Project: Eastern Creek Energy from Waste Facility (SSD6236 – D510/18).

Assessment of Response to DPE Assessment Report – dated 21.5.2018.

figure 1: site plan with locations of viewpoints selected by developer of new proposal

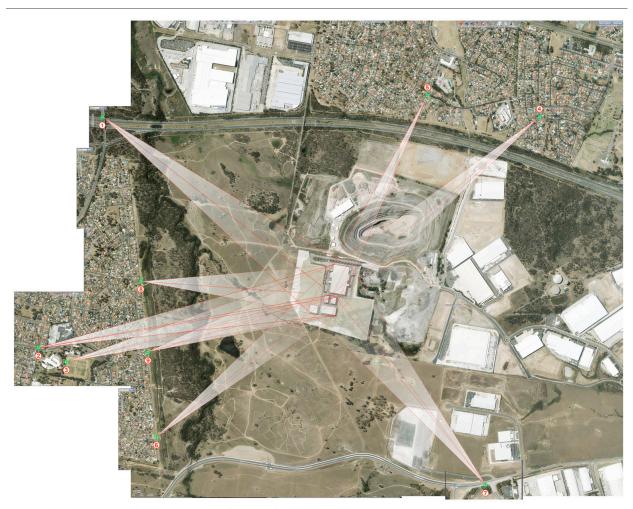
In terms of clearly demonstrating the visual impact to the residents in close proximity to the proposed development, this statement can be questioned. As can be seen in Figure 1, the viewpoints selected by the proponent do not give an objective starting point for the assessment of visual impact and may be potentially misleading.

The viewpoints that have been selected to the West of the subject site appear to have been deliberately chosen to minimise the impact of the new development. The Eastern boundary of the Erskine Park residential area is screened by mature trees bounding the edge of the public land. This screens the development, but the greater visual impact is not observed at these locations. The viewpoints to the North of the site have again been chosen to optimise the observed lack of visual impact, behind existing trees and elevated topography.

It is Urbaine's view that the applicant should be required to undertake an independent visual assessment report, highlighting those areas where the impact is greatest, whilst also giving an overall summary of view impact over the whole area surrounding the site.
